## Process Sheet

Customer	: CU-DAR001 Dart Helicopters Services	Drawing Name	: AFT TUBE ASSEMBLY
Job Number	: 30697		
Estimate Number	: 10699		
P.O. Number	: N/A	Part Number	: D3391025
This Issue	: 2/8/2007	Drawing Number	: D3391 REV E
Prsht Rev.	: NC	Project Number	: N/A
First Issue	: N/A	Drawing Revision	: E
Previous Run	: 30696	Material	: N/A
		Due Date	: 3/2/2007
Written By	:	Qty:	1 Um: Each
Checked & Approved By	:		
Comment	: Est Rev B 06-02-07 ECN773 dwg rev. D EC Est Rev: C 06-03-28 Update Manufacturing Instructions JLM

<b>DART AEROSPACE LTD</b>		<b>Work Order:</b>	30697
<b>Description:</b> Float Skidtube (412)		<b>Part Number:</b>	D3391-3
<b>Inspection Dwg:</b> D3391 <b>Rev:</b> E		<b>Page 1 of 1</b>

E	06.04.25	CHANGE TOLERANCE, EASE MANUFACTURE
D	06.01.23	UPDATE TOLERANCE, CHANGE HOLE SIZE
C	05.09.27	LENGTHEN AFT EXTENSION
B	05.06.10	DRAWING UPDATES
A	05.02.07	NEW ISSUE
DESIGN	PH	DRAWN BY PH
CHECKED	PH	APPROVED
DATE	06.04.25	TITLE
		412 FLOAT SKIDTUBE
		REV. E
		SHEET 1 OF 5
		SCALE
		NTS

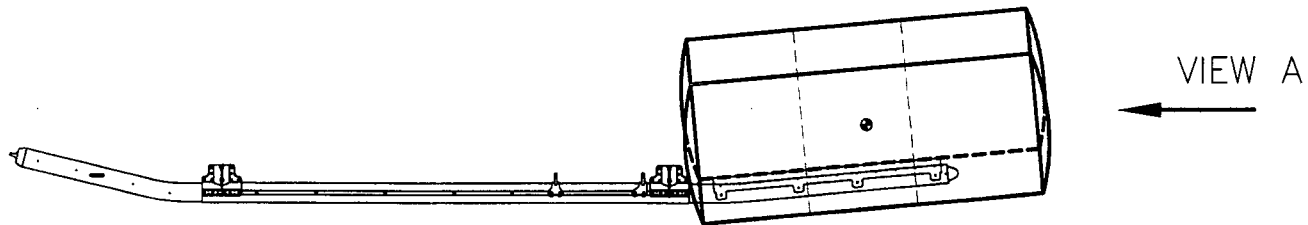
The aft float bag hole provisions are designed in order to have the aft float bag be vertical (i.e. the girt is 90 degrees to the horizontal)

In the manufacturing of the aft portion of the skidtube. The holes for the girt we have made are rotated 6.5 degrees with respect to the vertical, this was a manufacturing error. Therefore, when the bag is installed/or deployed it will be rotated 6.5 degrees (inboard or outboard). It will be inboard or outboard depending on which side of the aircraft the skidtube is installed, because the Dart 412 float skids aren't handed.

Is having the aft float bag rotated by 6.5 degrees inboard or outboard still acceptable for installation on aircraft?

As discussed with Bill, we have decided to allow the release of these skidtubes with the deviation noted below

I do not see an issue from a functional standpoint but, I am concerned that customers would object to their backed aft floats not being in alignment with the fwd and mid floats, especially since the aft floats will both lean to one side.
